- Request - Preliminary Drawing for Fieldview Addition Being a Replat of Gardenview Acres Lot 1
- Location - 0 Greystone Parkway
- Applicant / Developer - Deon Davis
2460 N. Reynolds Road
Toledo, OH 43615
- Surveyor / Engineer - Lewandowski Engineers, A Verdantas Company
219 S. Erie Street
Toledo, OH 43604

The staff recommends that the Toledo City Plan Commission **approve** S24-0016, a Preliminary Drawing for Fieldview Addition Being a Replat of Gardenview Acres Lot 1, for the following **two (2) reasons**:

PRELIMINARY PLAT
TOLEDO CITY PLAN COMMISSION
REF: S24-0016
DATE: March 13, 2025
TIME: 2:00 P.M.

PRELIMINARY DRAWING OF: FIELDVIEW ADDITION BEING A REPLAT OF GARDENVIEW ACRES

PRELIMINARY PLAT

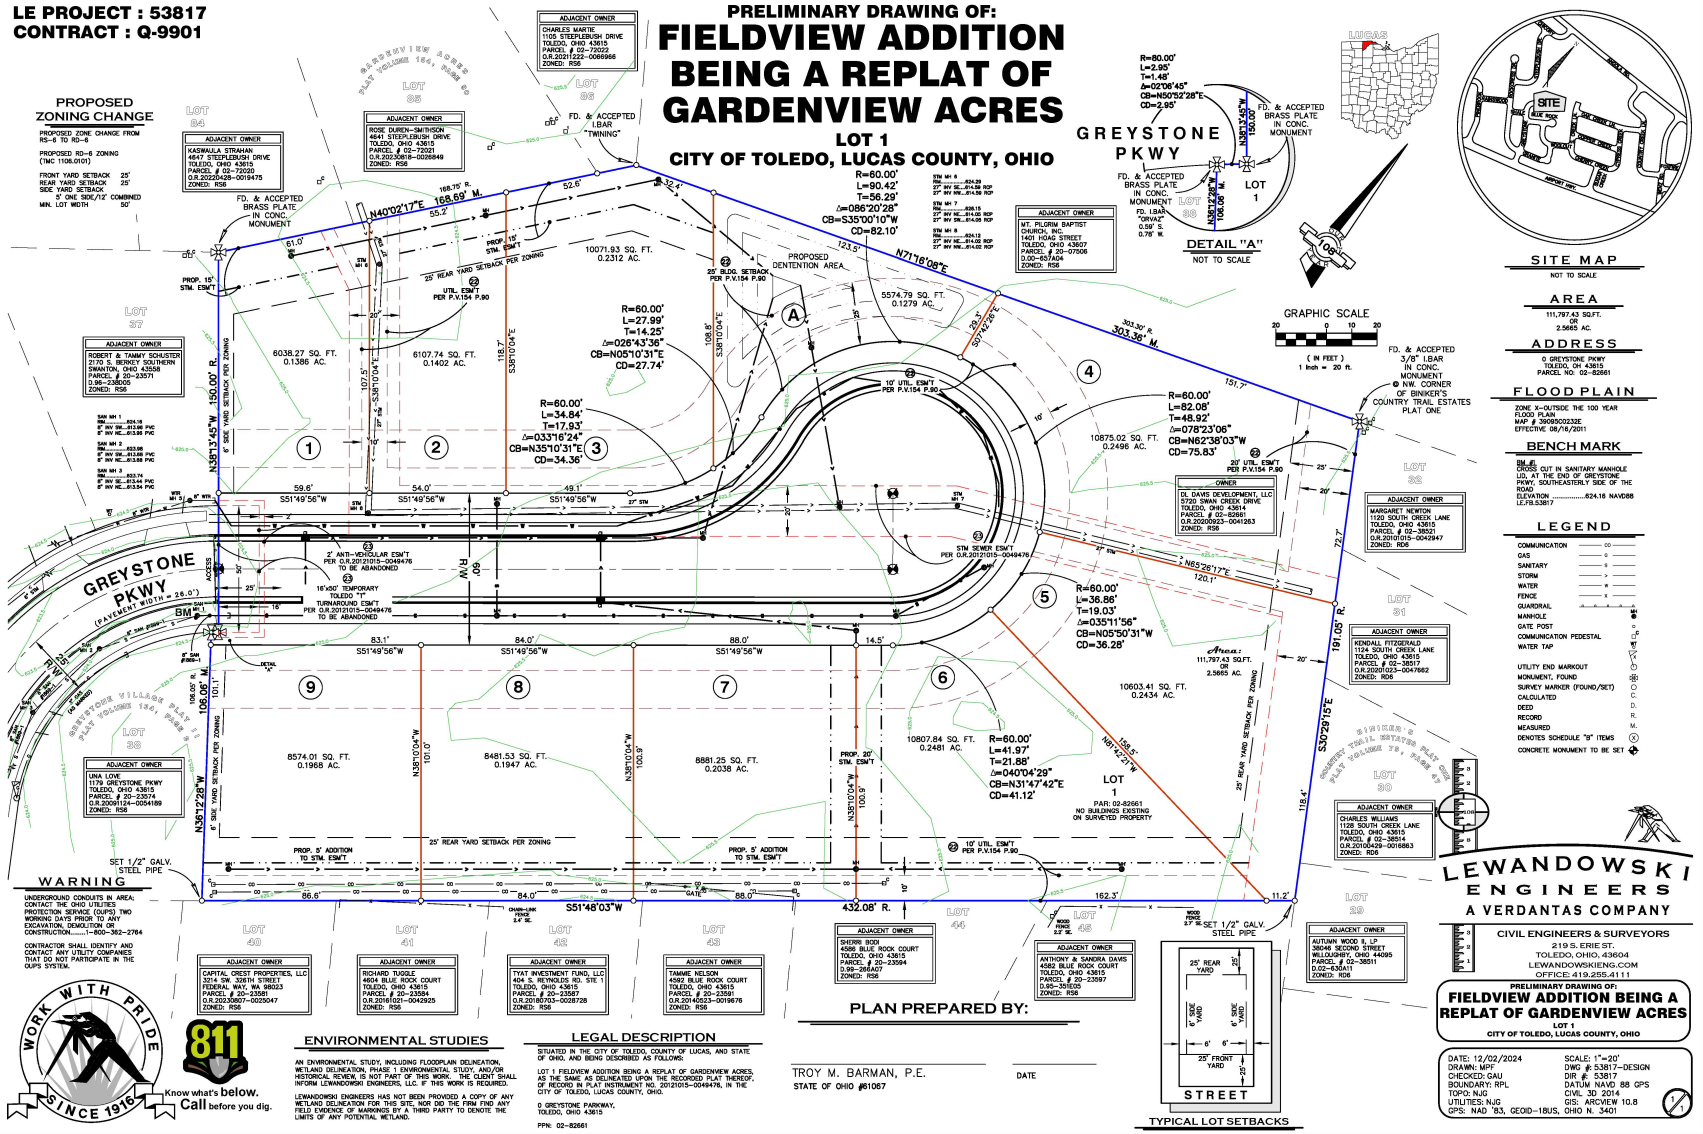
5. Water service for this development is available subject to the Rules and Regulations of the Department of Public Utilities.
6. Maintain a minimum of 10 feet of clearance between the proposed water main and proposed storm and sanitary sewers. Maintain a minimum of 10 feet of clearance between proposed hydrants and proposed storm and sanitary sewers.

10. Sanitary sewer shall be completely within the proposed right-of-way. Sanitary sewer shall be a minimum of 10 feet inside of the proposed right-of-way.

11. Each lot shall have a separate sanitary sewer tap from the main line.

12. Markups on the preliminary drawing submitted by the Chief Surveyor on 12/11/24 shall be addressed on the final plat.

13. A Fire Hydrant is required to be placed on the extension of Greystone Pkwy. The closest fire hydrant is on Greystone at Shale Lane, which puts the end of Greystone Pkwy addition at 500 feet from the closest hydrant. Toledo Municipal Code requires a hydrant within 350 feet and the Ohio Fire Code requires a hydrant within 400 feet. (OFC 507.1 and 507.5.1, TMC 1511.03, rule 5, #1)

16. The east-west portion of the proposed right-of-way shall be an extension of Greystone Parkway and shall be named as such on the Final Plat. Street addresses shall be assigned by the Division of Engineering Services.
